RE: Blythe Solar Power Project, Docket No. 09-AFC-6
Responses to January 15 and 20, 2010 CEC Email Query from CEC staff, Additional Information regarding
Transmission System Engineering.

**Responses to CEC Email Requests,
January 15, 2010
Transmission System Engineering**

Blythe Solar Power Project

Data Response Queries – January 15, 2010

Figure 2-9

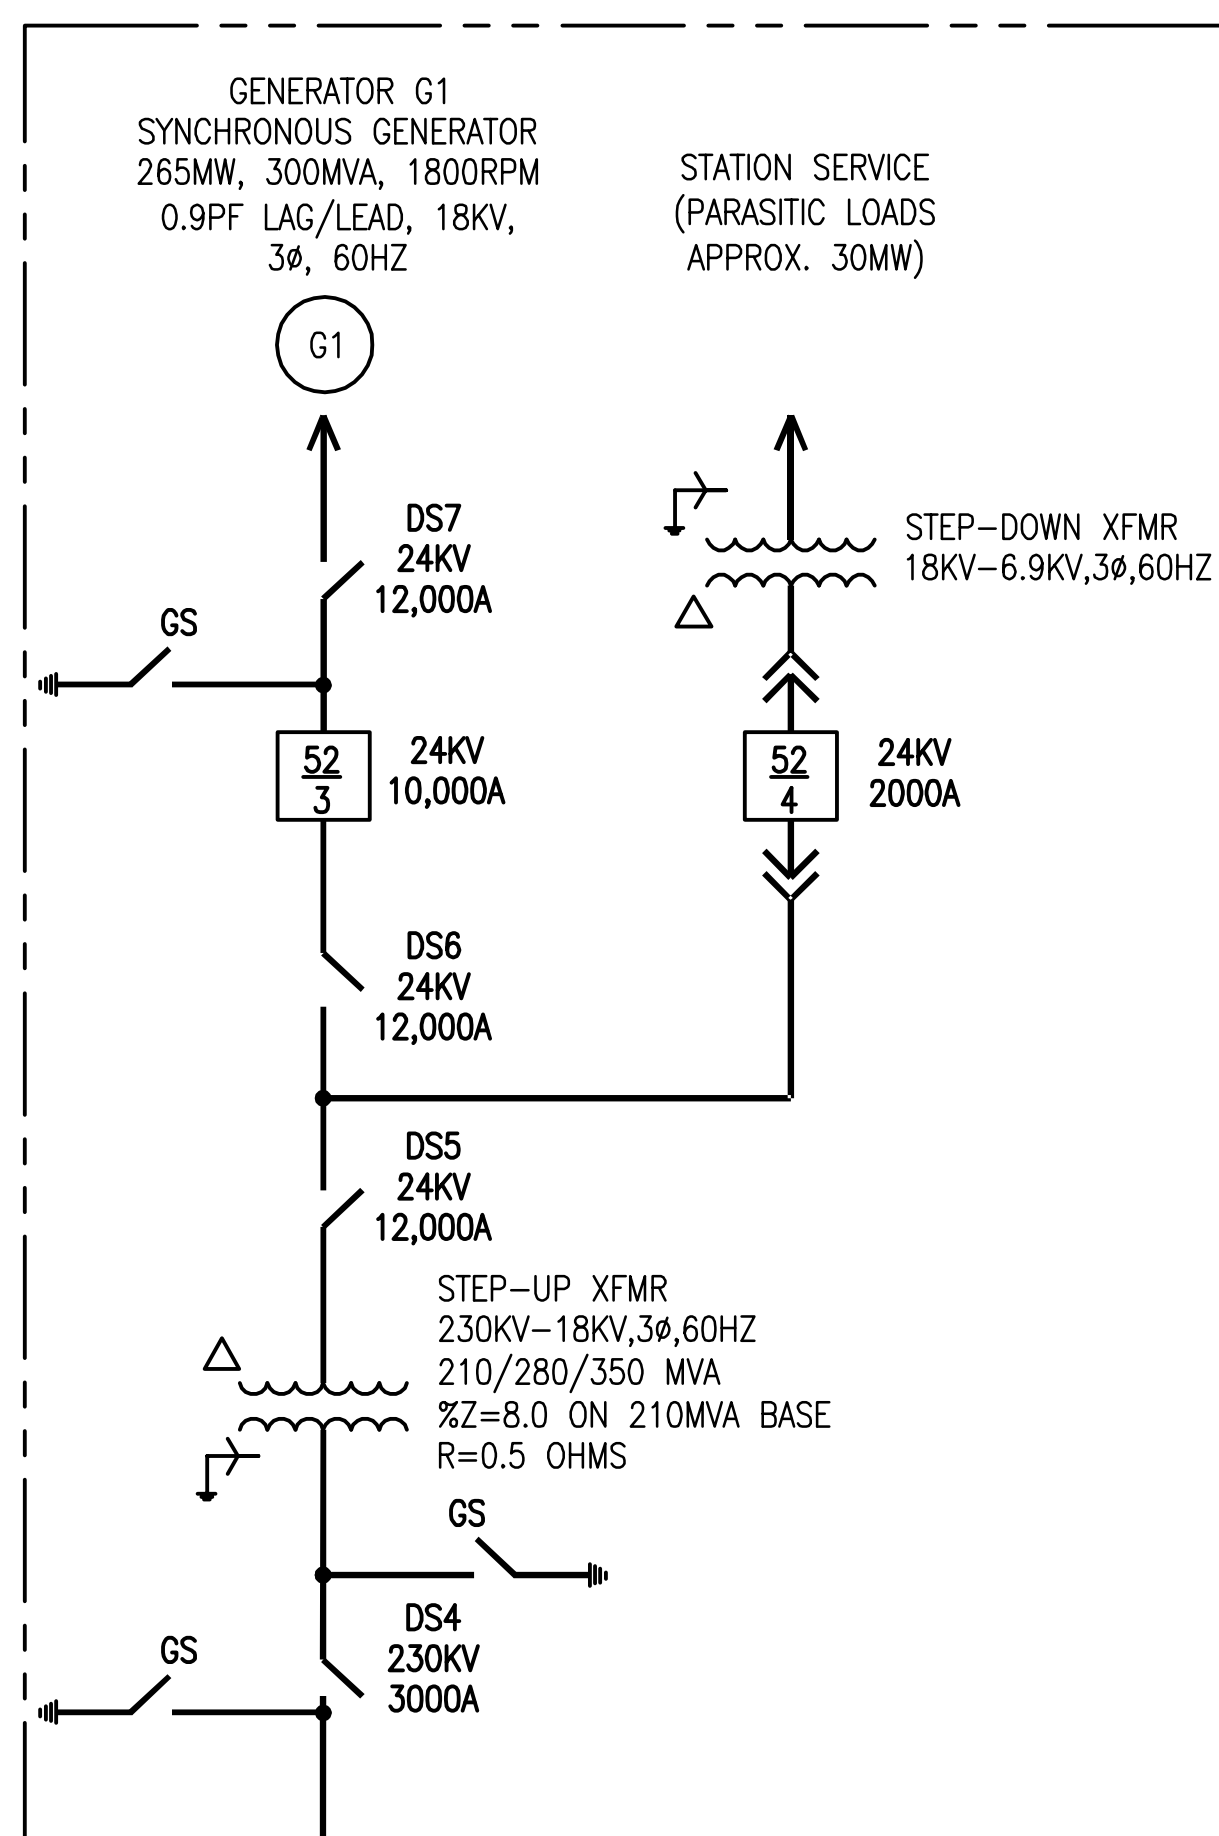
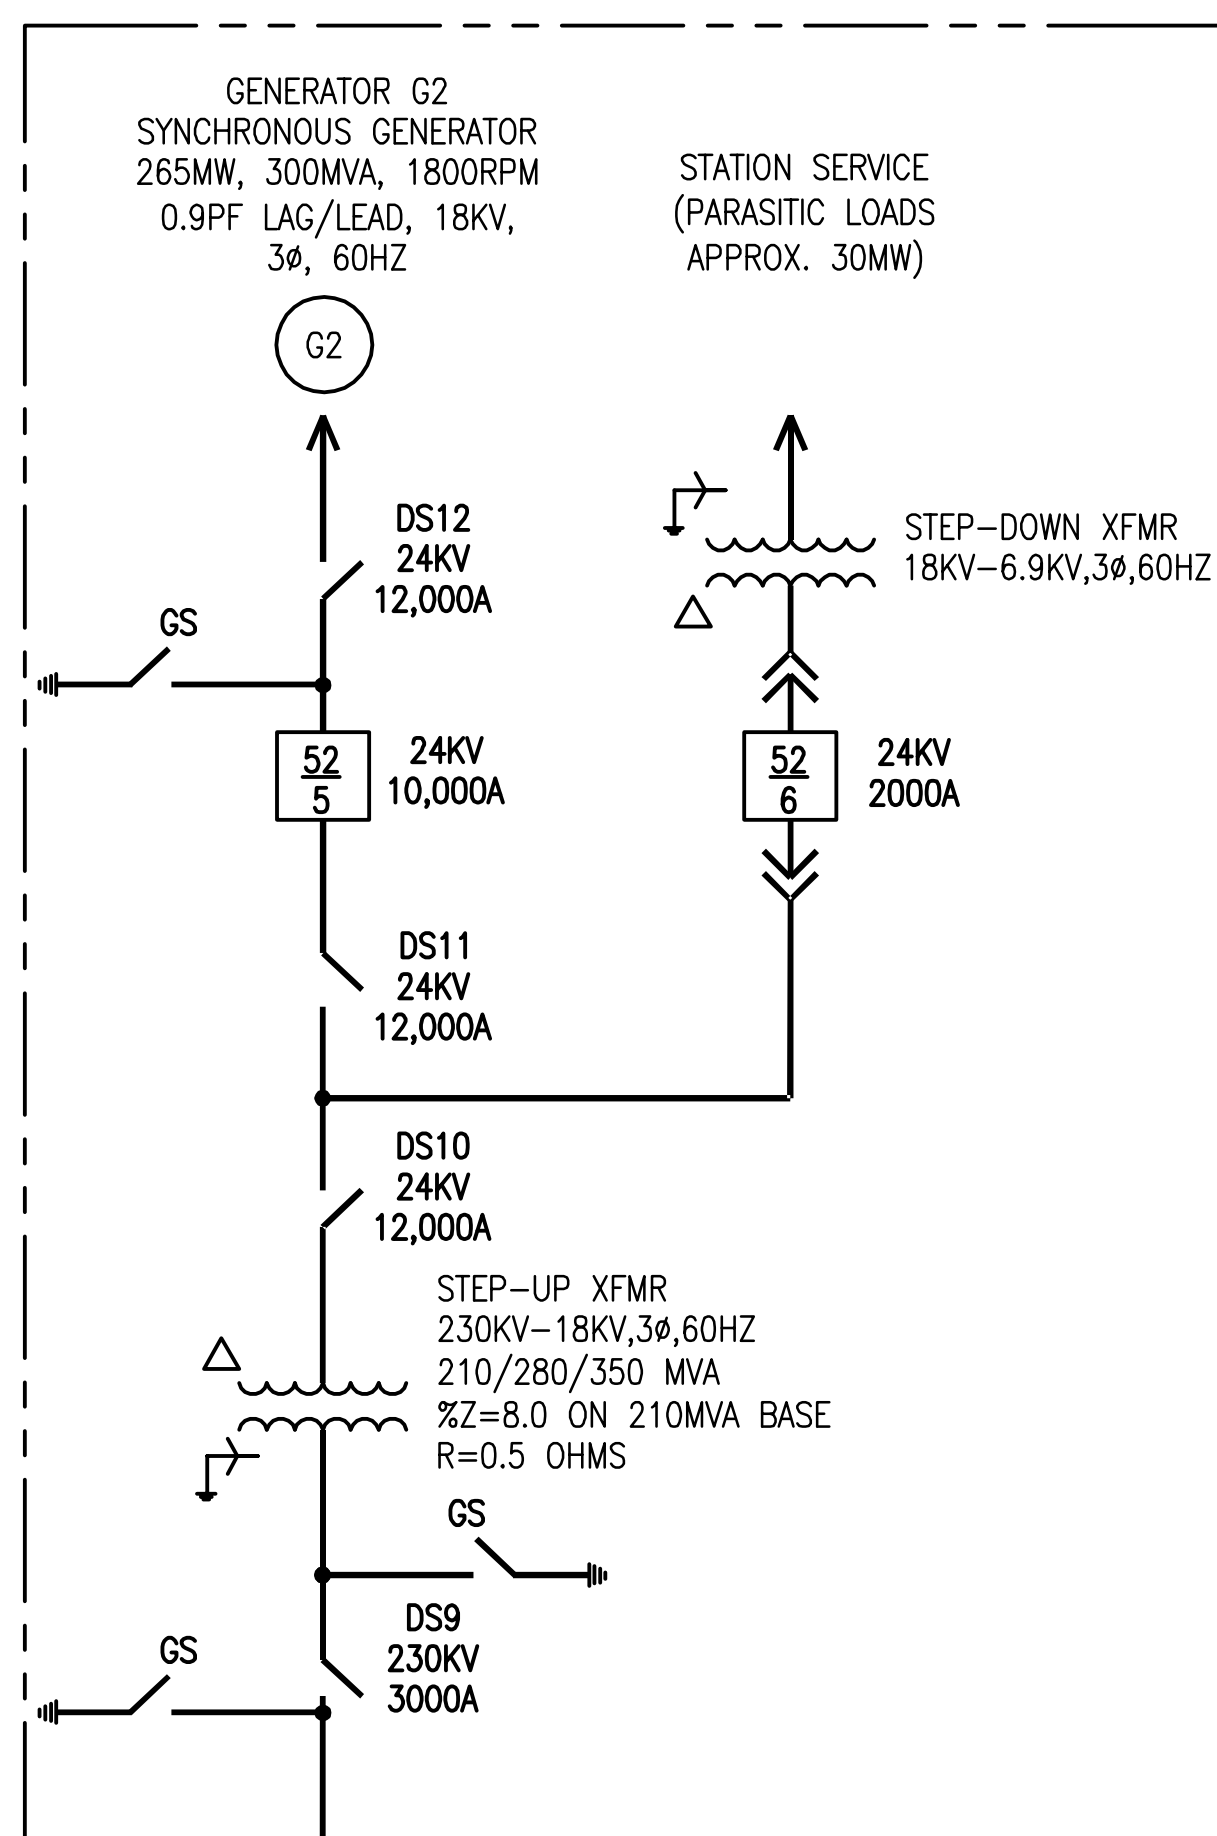
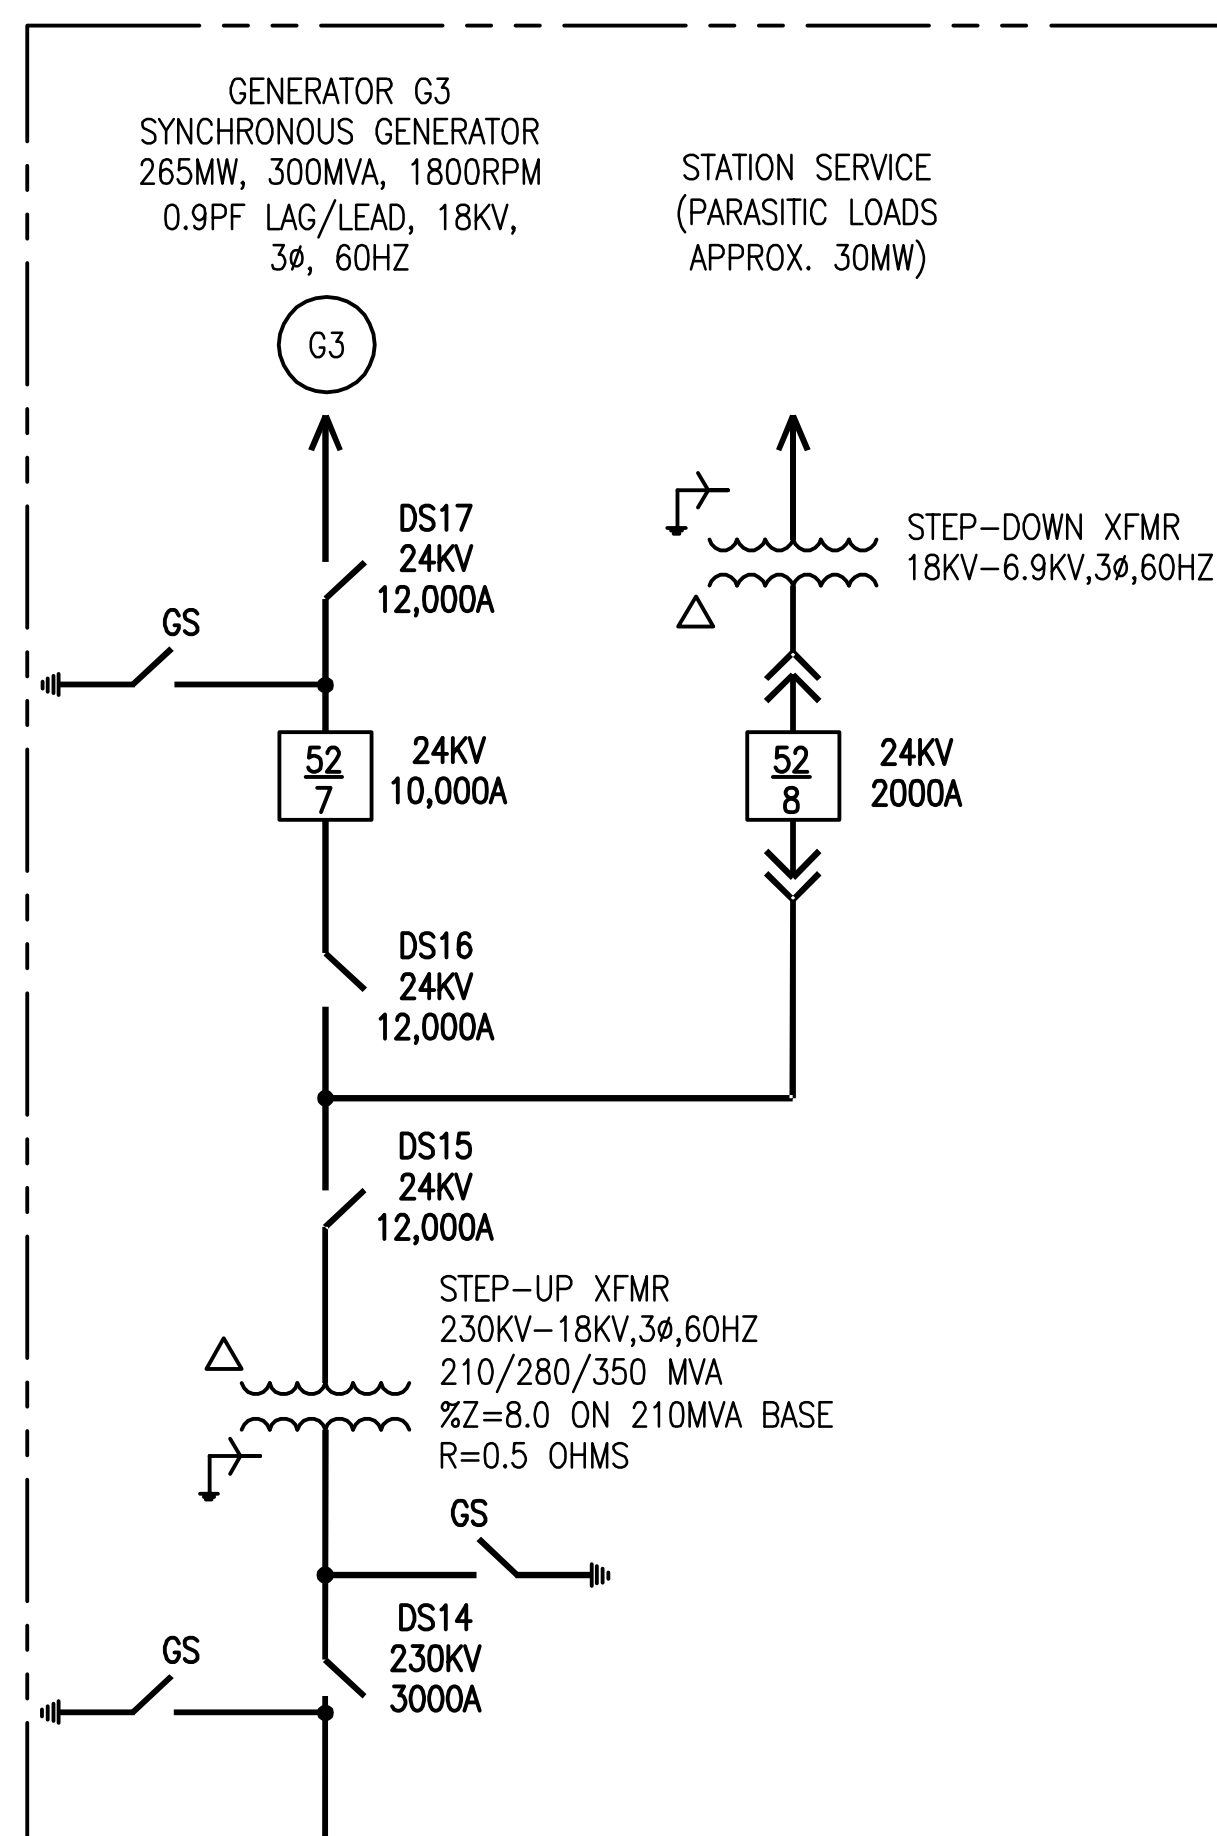
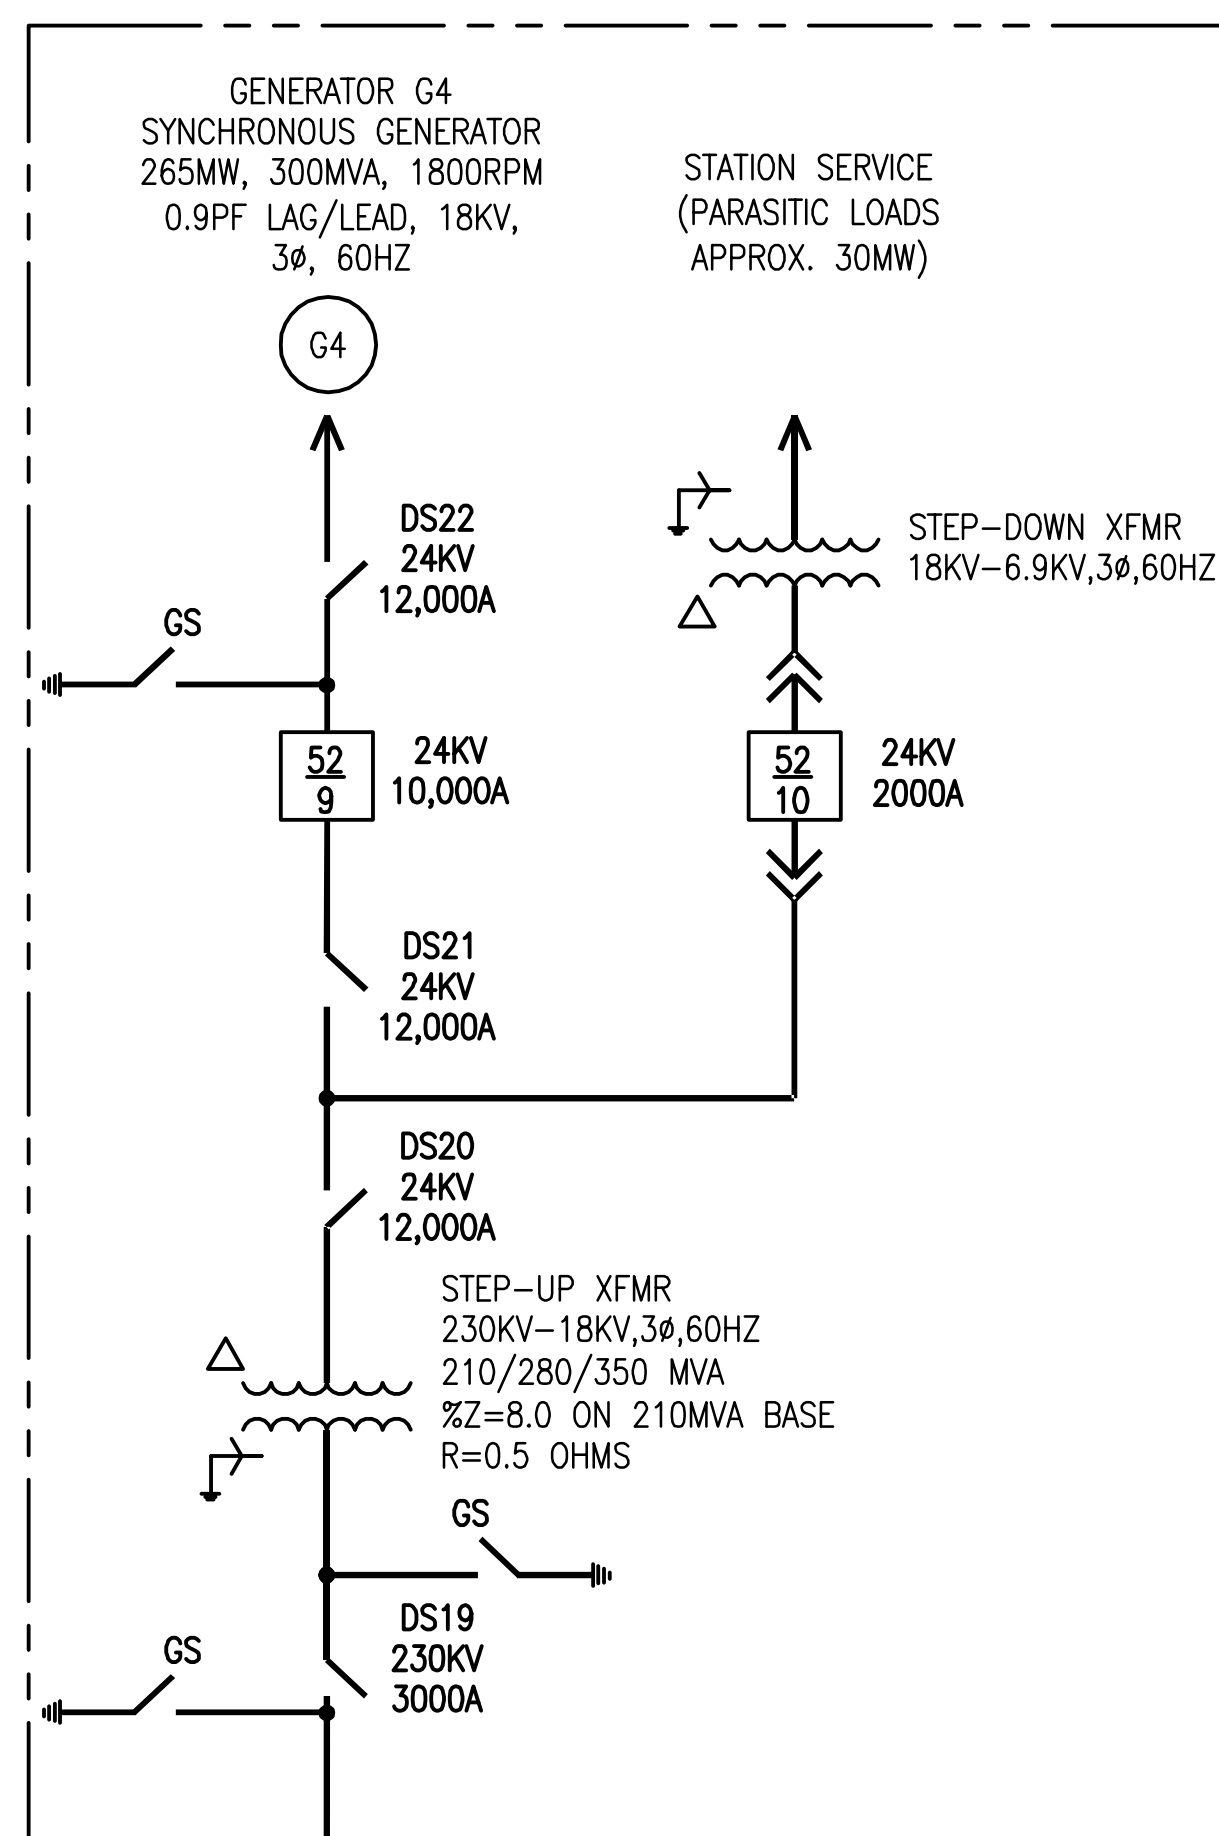
1) Clarify the proposed voltage and step up voltages.

4) Update Figure 2-9 (one-line for the generators and gen-tie), Figure 2-14 (pole), and Figure 2-15 (Colorado River Substation connection). Figure 2-15 needs to show step-up transformer connection and transformer data.

The T-line voltage has been previously provided on Figure 2-9. Additional voltage information is identified on Figures 2-14, 2-15, and 2-15a which are provided as attachments to this submittal. The step-up voltages are provided on Figures 2-8, 2-9, and 2-15a also provided as an attachment to this submittal.

Figure 2-9 was previously provided as stated above. Figure 2-14 is being provided. Applicant's Figure 2-15, Colorado River Substation SLD, is limited to Palo Verde I, LLC's scope of supply. SCE 230kV/500kV step-up transformer connection and transformer information is provided, however, on Figure 2-15a.
